TO: All Registered Bidders
DATE: November 4, 2024
PROJECT: Colton Joint Unified School District
Ruth Grimes E.S. Phase II Classroom Addition
A# 04-123534
BID#: 25-003FAC
DSA# A# 04-123534
CONTACT: Owen Chang

2024 PHASE II SITE UPGRADES
(TK + K MODULAR ADDITION)
COLTON JOINT UNIFIED SCHOOL DISTRICT

SHEET NO.
F2.10

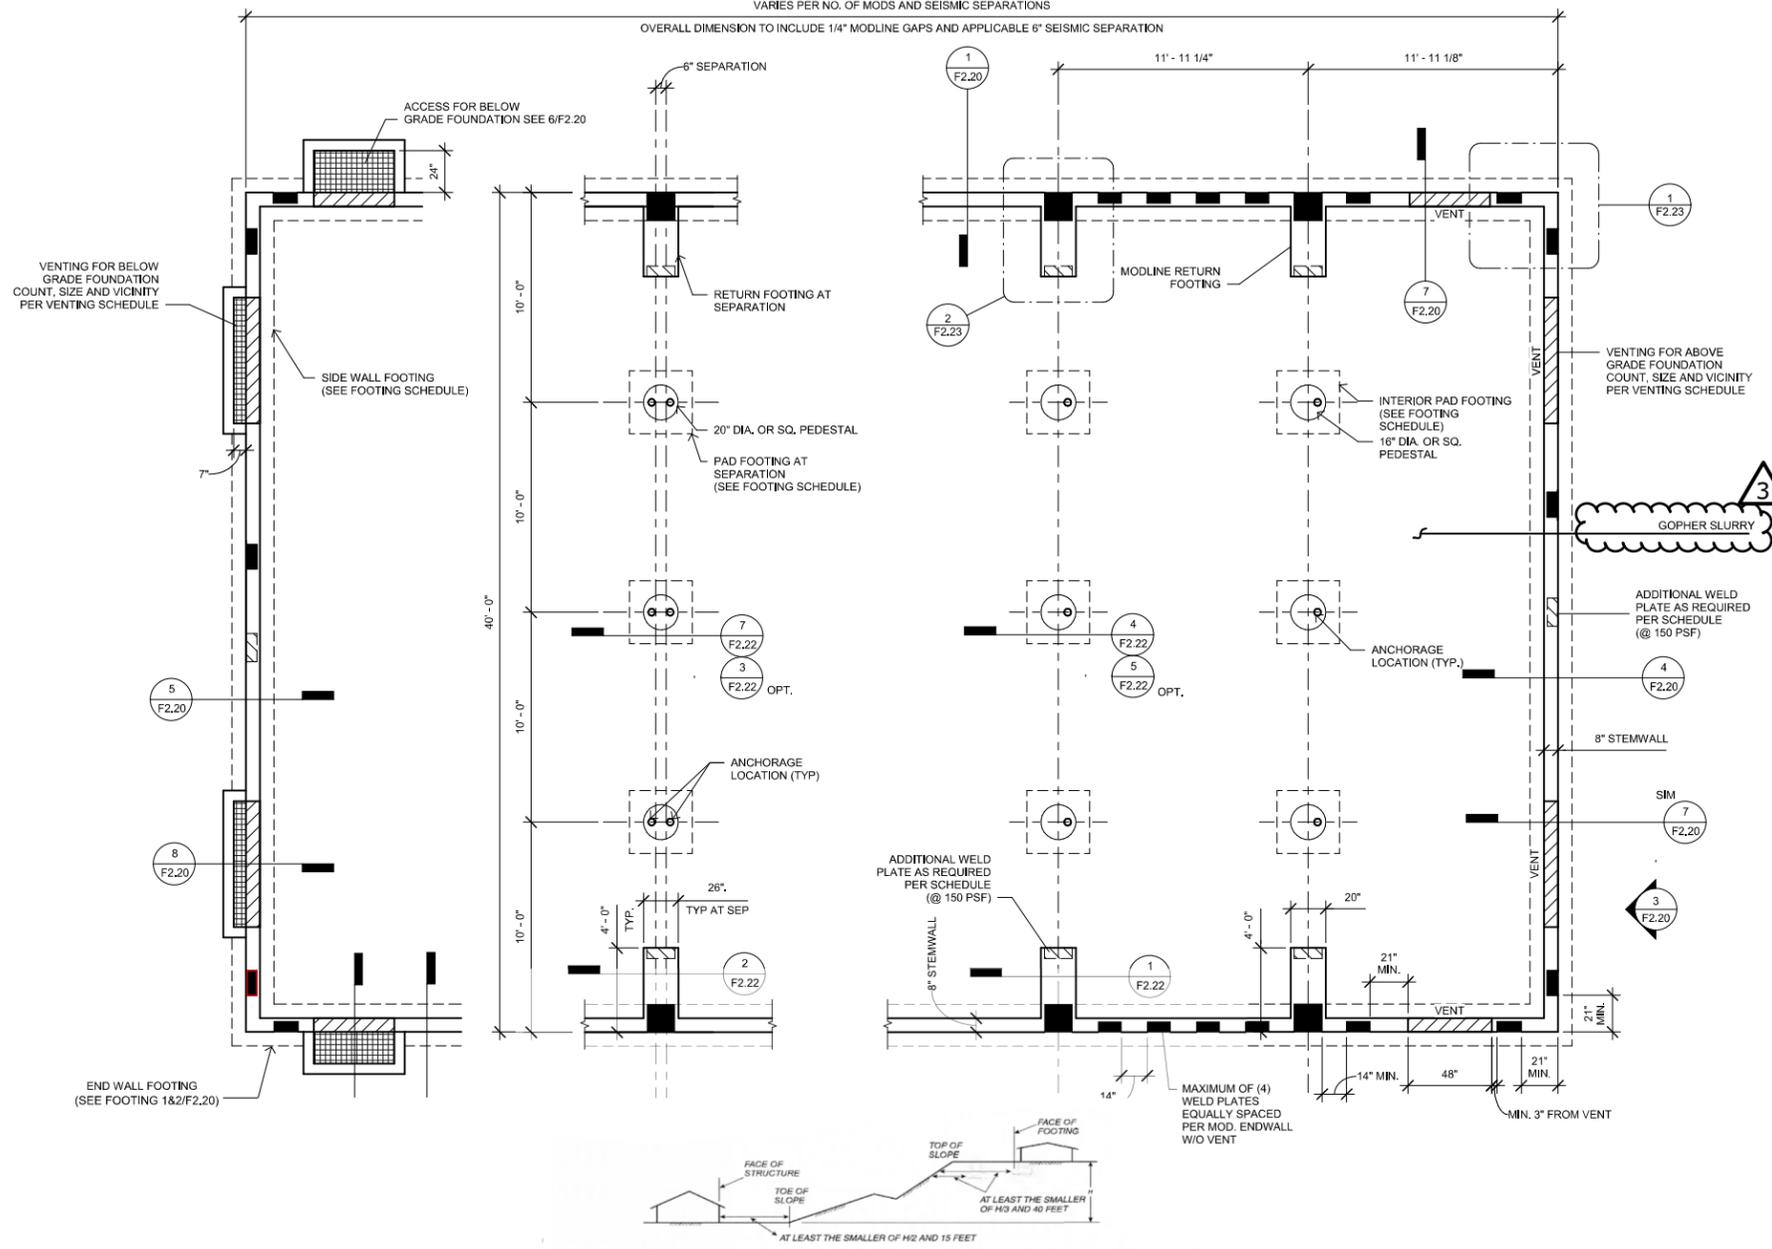
2. REFERENCE Sheet F2.10 CONCRETE FOUNDATION PLAN
 - A. REMOVED the word "OPTIONAL" from gopher slurry note
3. REFERENCE Sheet F2.20 CONCRETE FOUNDATION DETAILS
 - A. ADDED mark to indicate selection of Optional 2" Gopher Slurry on details 2, 5, and 8.
4. REFERENCE Sheet F2.22 CONCRETE FOUNDATION DETAILS
 - A. ADDED mark to indicate selection of Optional 2" Gopher Slurry on details 1, 2, 4, and 7.
